1 Building Elevation - East 3B2
1 : 200

2 Building Elevation - West 3B2
1 : 200

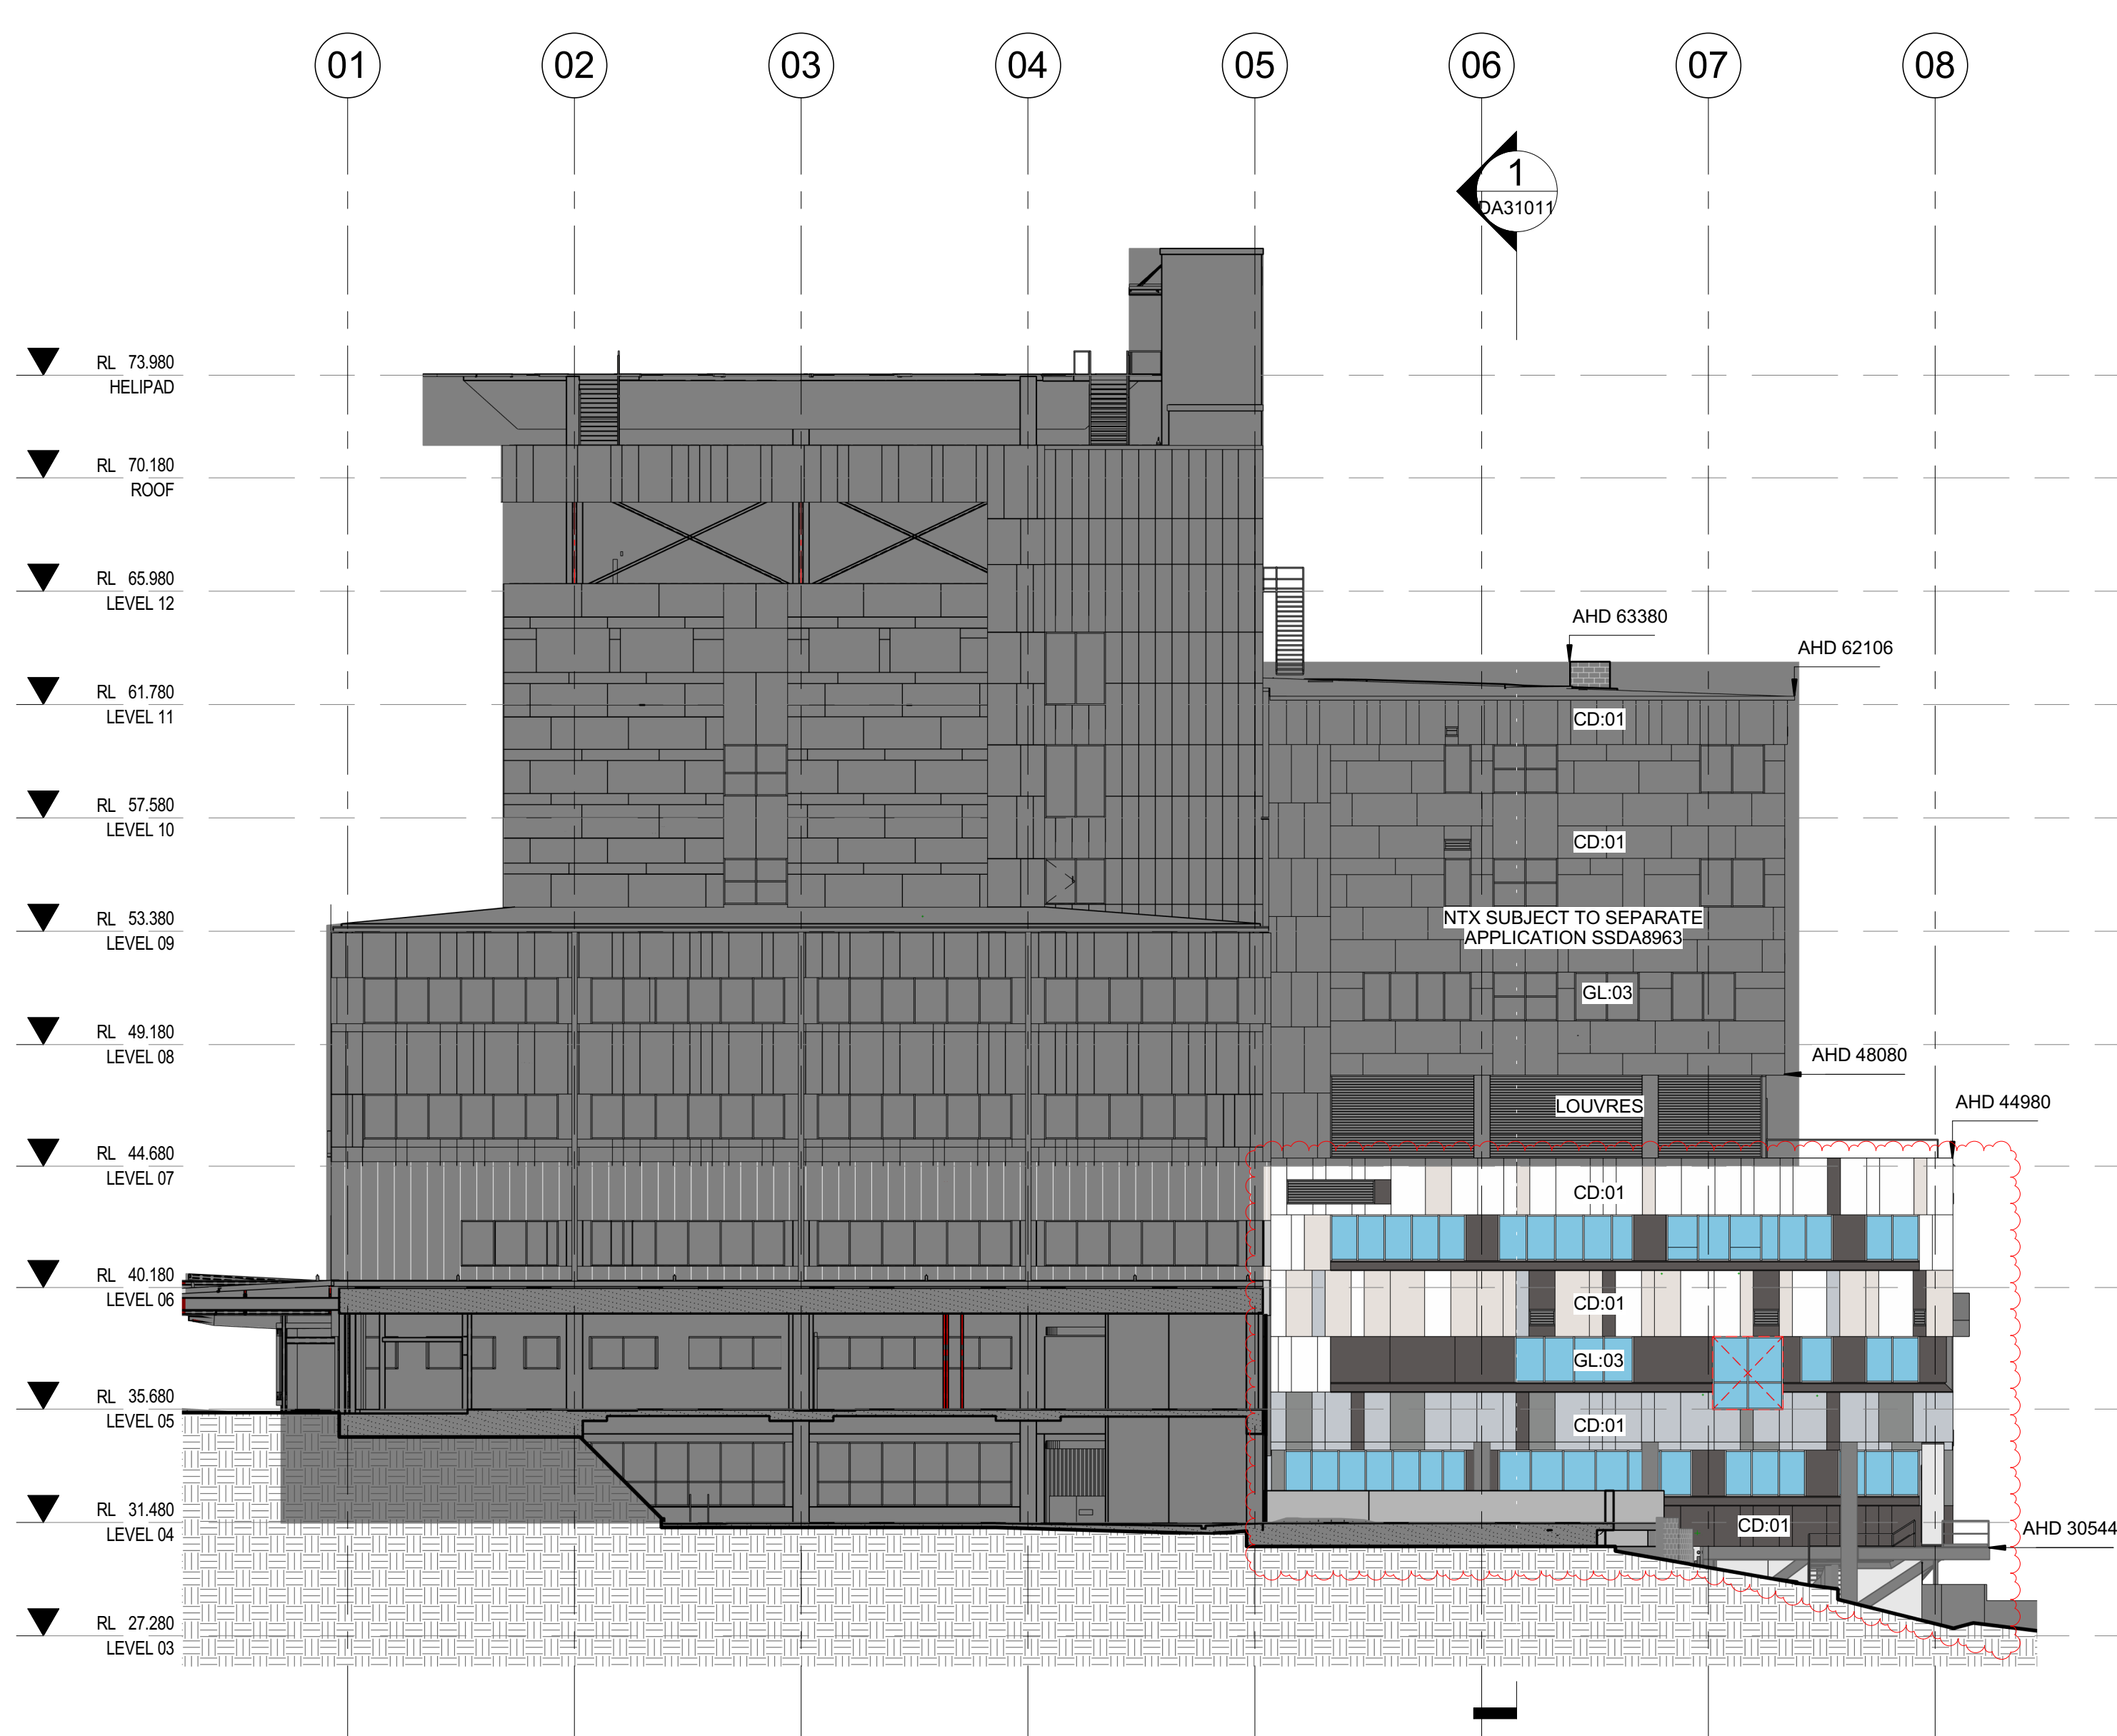
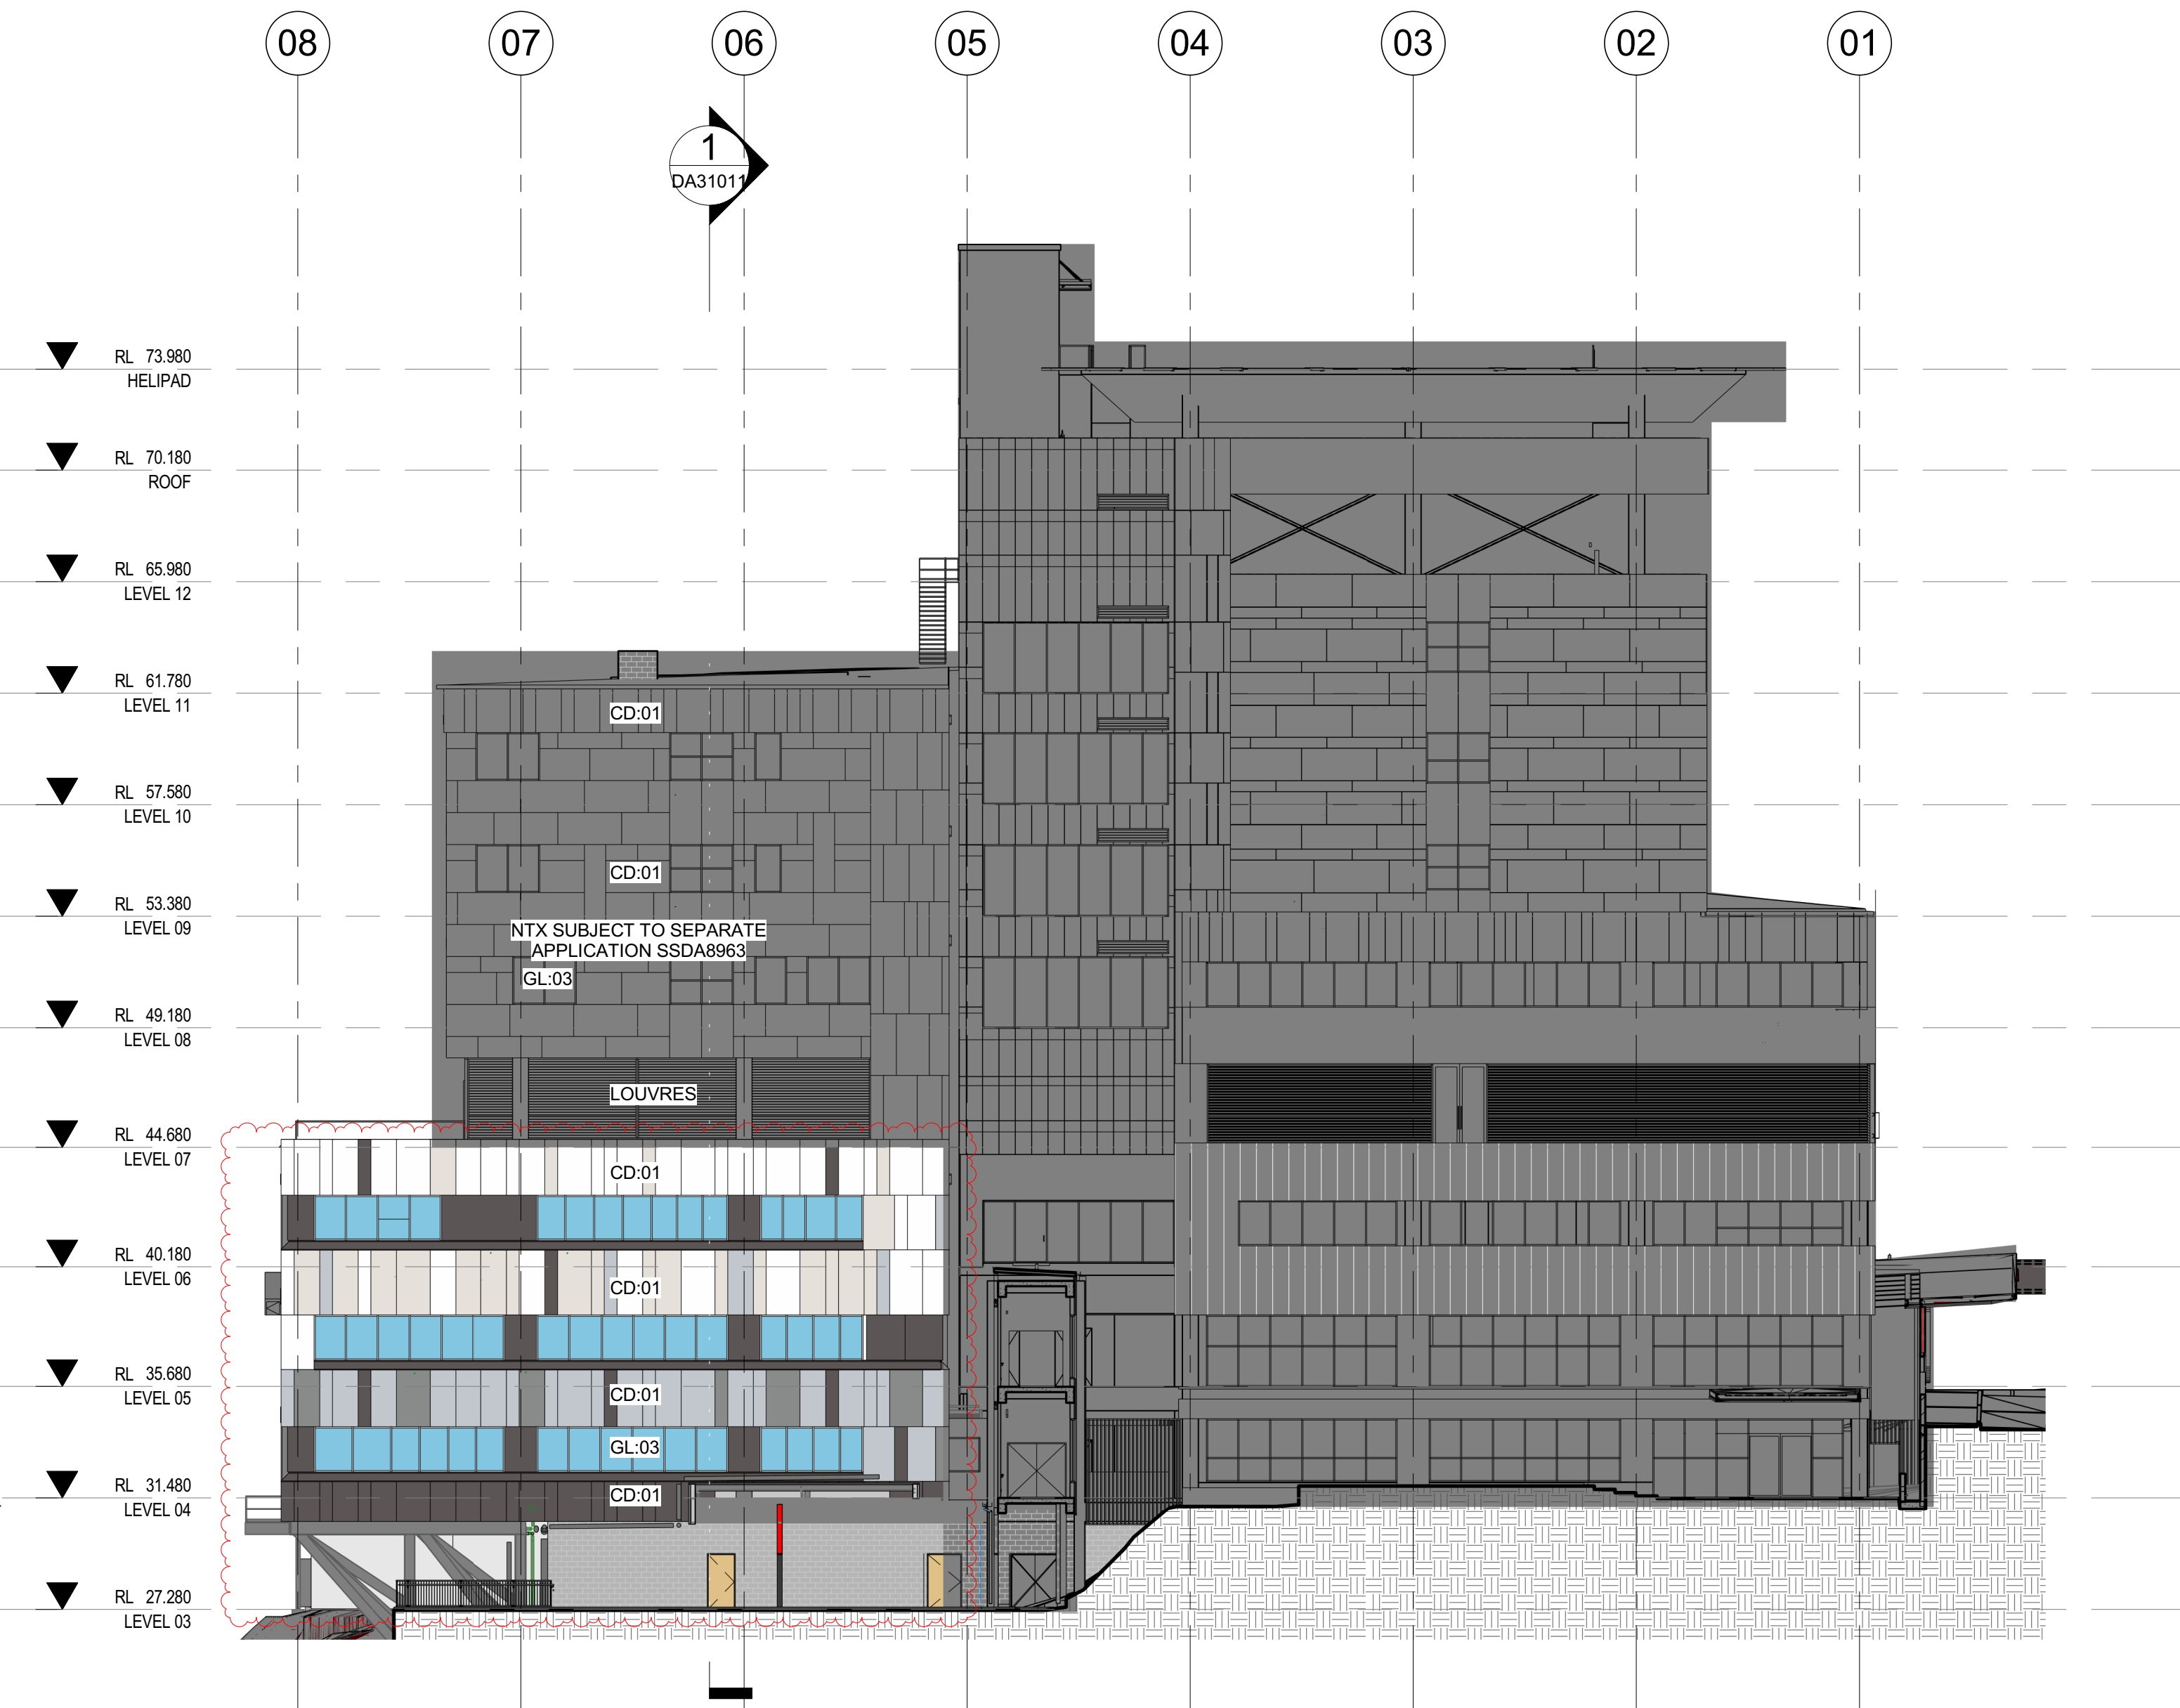
Schedule of Changes	
Item	Comments
1	Incorporation of quench pipe box on Northern Facade
2	Amendment of design language to facade
3	Change of colour palette to facade
4	Incorporation of large removable window for MRI
5	Incorporation of elevated walkway to Level 04
6	Reconfiguration of Level 03 to accommodate altered plant as a result of extension
7	Level 03 extent of louvre panelling reduced
8	Coordination of Mechanical design with external louvres
9	Windows amended suit internal layout
